Job Sheet 181228

Part Name: Window

DART AEROSPACE LTD HAWKESBURY, ONTARIO, CANADA	
DRAWING NO. D3290	REV. C
TITLE REPLACEMENT WINDOW ASSEMBLY	SHEET 1 OF 2
SCALE 1:5

DRAWING NO. D3290	TITLE REPLACEMENT WINDOW ASSEMBLY	REV. C	DART AEROSPACE LTD ENGINEERING ORDER		D.E.O. NO. D3290-C-1	SHEET NO. SHEET 1 OF 1	SCALE NTS
DRAWN <i>q</i>	CHECKED <i>b</i>	MFG. APPR. <i>E</i>	APPROVED <i>MP</i>		DE APPR. <i>#</i>		
DATE 09.09.18	DATE 09.09.18	DATE 09.09.18	DATE 09/09/21		DATE 09/09/21

D3290-1 FRAME

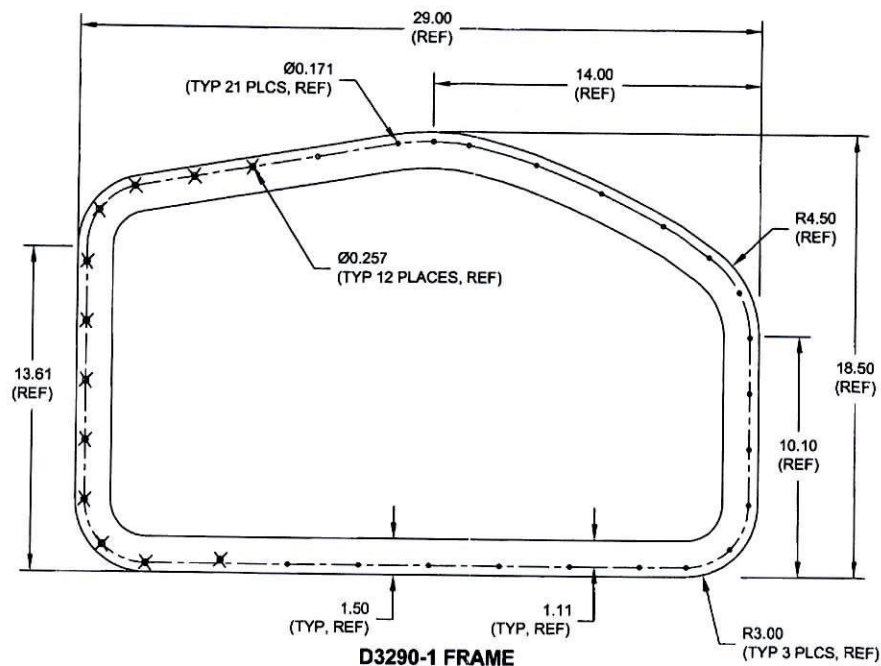
CHANGE MATERIAL THICKNESS OF D3290-1 FRAME TO 0.063 FROM 0.040. REF PAR 09-033.

MATERIAL CALL-OUT OF D3290-1 FRAME ON SHEET 1 IS AMENDED AS FOLLOWS:

- 1) MATERIAL: 6061-T6 (OR 6061-T62) ALUMINUM SHEET ~~0.040 THICK~~ 0.063 THICK (REPLACE)
 PER AMS-QQ-A-250/11 OR AMS 4025 OR AMS 4027
~~(REF. DART SPEC. M6061T6S.040)~~ REF. DART SPEC. M6061T6S.063 (REPLACE)
 OR
 5052-H32 ALUMINUM SHEET ~~0.040 THICK~~ 0.063 THICK (REPLACE)
 PER AMS-QQ-A-250/8 OR AMS 4016
~~(REF. DART SPEC. M5052H32S.040)~~ REF. DART SPEC. M5052H32S.063 (REPLACE)
